Subject: **Updated Responses to Request for Supplemental Information 5-1 for the Application for the SENTRY™ Dry Storage Cask System (Certificate of Compliance [CoC] No. 72-1026; Proposed Amendment 5)**

Updated Response to Request for Supplemental Information 5-1
Docket No. 72-1026
SENTRY™ Dry Storage System
Certificate of Compliance No. 1026

RSI 5-1

Figure 5- 1 - Dose Rate Characterization

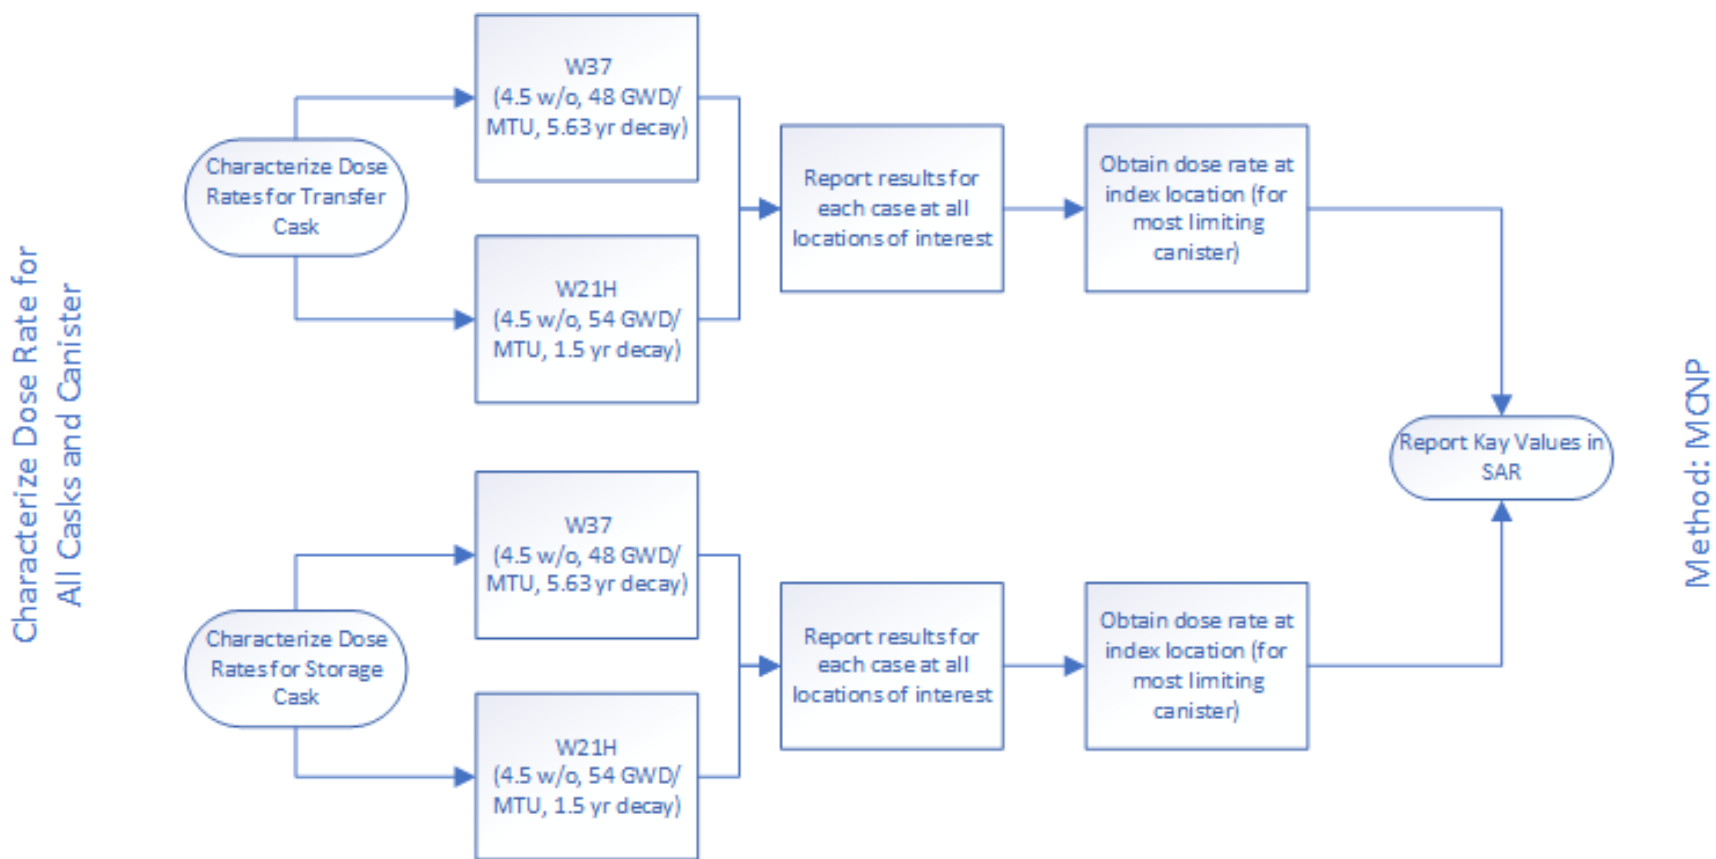
Provide code benchmarking analyses for the DORT code for shielding analyses or references that demonstrate the code has been adequately benchmarked for this application.

The applicant used the DORT code to calculate the adjoint function that is used in the shielding calculation. In accordance with the ANSI/ANS standard ANSI/ANS-6.1.2-2013¹, the analyses performed for numerical benchmarking shall be documented in sufficient detail to allow an experienced shielding analyst to duplicate the results. In order to assure the validity of the method of evaluation for shielding design, it is imperative to have the code benchmarked for the specific application. However, the applicant provides little information regarding how the code is benchmarked for this application. In addition, in the description of the DORT code, the Nuclear Energy Agency (NEA)² states: “[T]he Boltzmann transport equation is solved, using either the method of discrete ordinates or diffusion theory approximation. In the discrete ordinate’s method, the primary mode of operation, balance equations are solved for the flow of particles moving in a set of discrete directions in each cell of a space mesh and in each group of a multigroup energy structure.” It does not provide code benchmarking or references that demonstrate the code has been adequately benchmarked for this application. As such, the staff cannot determine if the code is appropriate for this application.

Figure 5-1 diagrams the process used for characterizing the dose rates for all casks and canisters. These analyses are performed and reported based on the base case state points described above. This work is performed by means of the MCNP code.
